WILLIAMSVILLE, ILLINOIS
MAIN STREET
M.P. 173.00
SPRINGFIELD SUBDIVISION
D.O.T.#294 275U

Date: 04/01/02	**UNION PACIFIC RAILROAD**		Sh.: 1
Des: WIT	WILLIAMSVILLE, ILLINOIS		DOT 294275U
Chk: JJF	MAIN STREET		MP: 173.02
AFE: 00183	SPRINGFIELD SUBDIVISION		ID: CSL17302.1X
DES: WITT.IND.	Office of AVP Engineering-Signal	Omaha, Nebraska	DATE 4-1-02
DIG: WITT.IND.	UNION PACIFIC RAILROAD		SHEET 1
CHK: J.J.F.	BLOOMINGTON, ILLINOIS TO		DWG 173.00
A.F.E. 00183	VALLEY JCT., ILLINOIS		RTE CSL
ID: CSL17300.1X	C.T.C. CIRCUITS		
	Office of AVP Engineering-Signal	OMAHA, NEBR.

Designed: 2/25/15
TIER 3 PHASE 3
M.P.177.00 TO
M.P.160.00
HSR SCOPE CHANGE
Rec': WO': 22820
IS: MWK/
/NST/JXJ

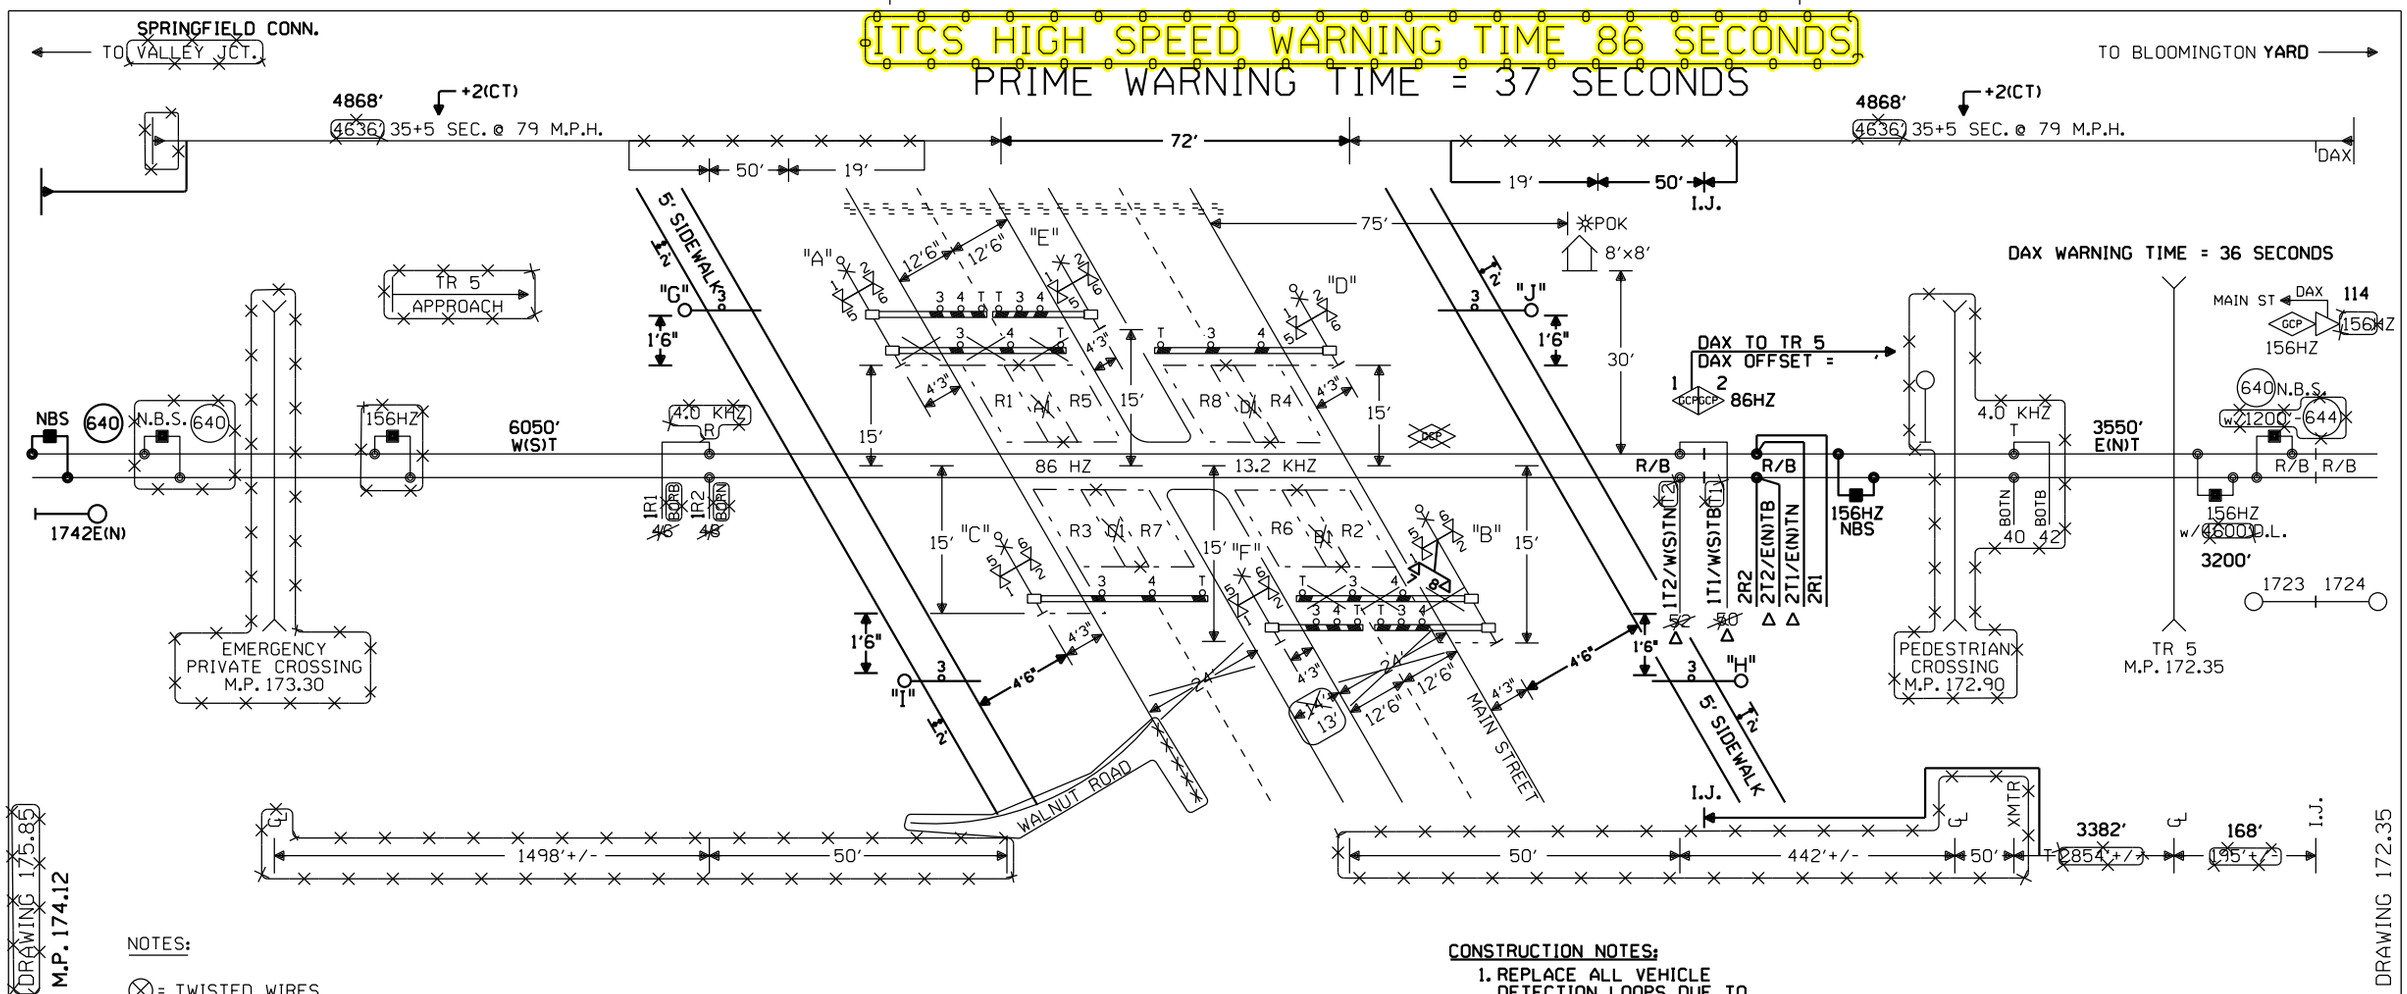
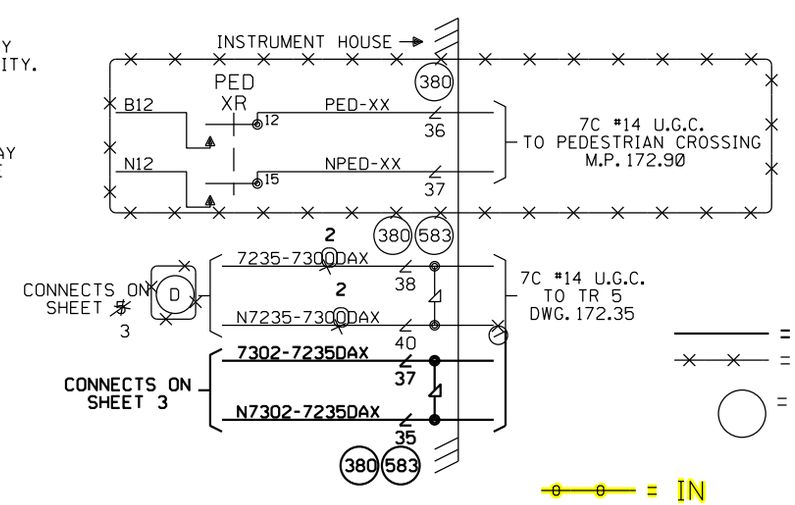
LIGHTS: LED LIGHTS
GATE A,B: 18'
~~GATE A,C: 32'~~
GATE C,D: 32'
~~GATE B,D: 32'~~
GATE E,F: 18'
GATE G,H, I, J: 8'

1. REPLACE ALL VEHICLE DETECTION LOOPS DUE TO FULL DEPTH PAVEMENT REPLACEMENT.
2. RUN ALL NEW TRACK WIRES

•• MAKE TITLE BLOCK CHANGES TO ALL SHEETS ••

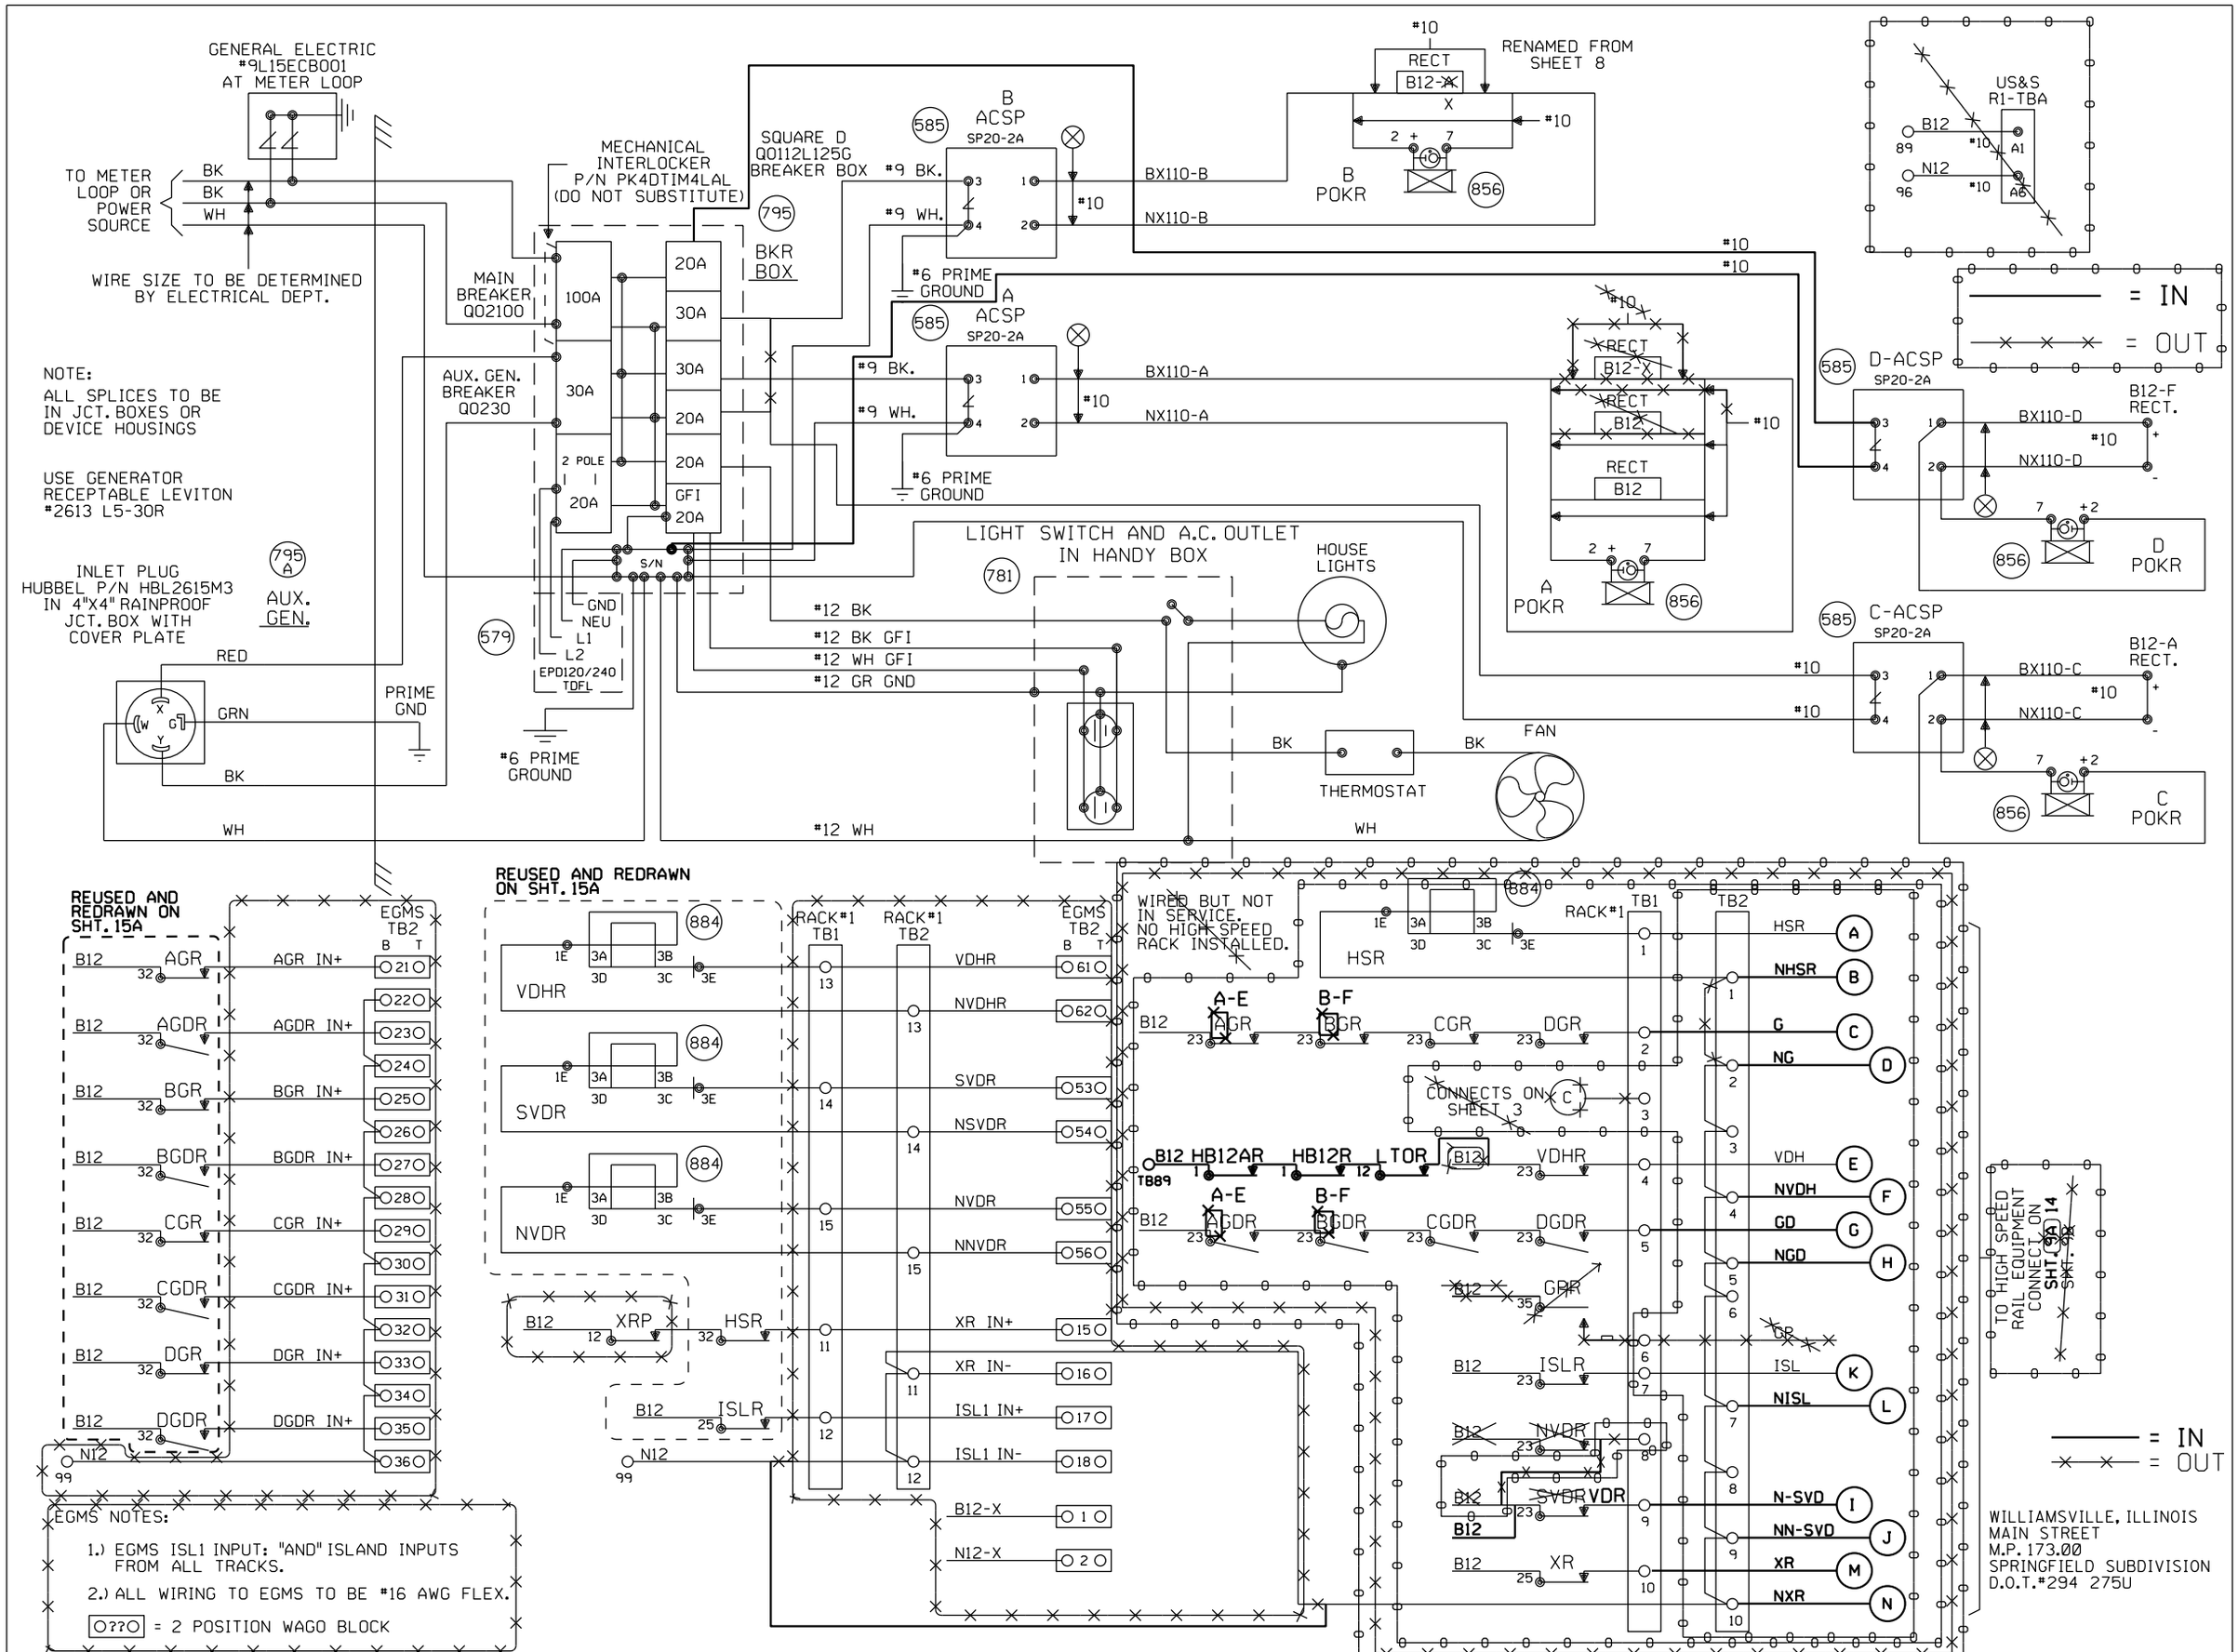
- The Advance Start Enable test switch is open.
- The Crossing has been activated longer than ~~2~~ 3.5 minutes but less than 5 minutes, without a train present on the crossing.
- The loss of communitations longer than 2 minutes 30 seconds.

- Activation failure detected. (~~A~~ No vertical gate ~~not~~ contact indicating de-energized within 10 seconds of request for crossing to activate)

If this failure has occurred it requires the advance start enable test switch to be opened to reset the box before any further High Speed operation is allowed.
- The crossing has been activated longer than 5 ~~minuts.~~ minutes, without a train present on the crossing.
- The vehicle detector does not indicate clear, or the Gate Down circuit not energized within 20 seconds (Field adjustable) of crossing being requested to activate.
- The vehicle detector health not true. This input consists of the detector loop health, EGMS health, Battery health, and Long Term Occupancy of Vehicle Detector Loop (Greater than 1 minute.)
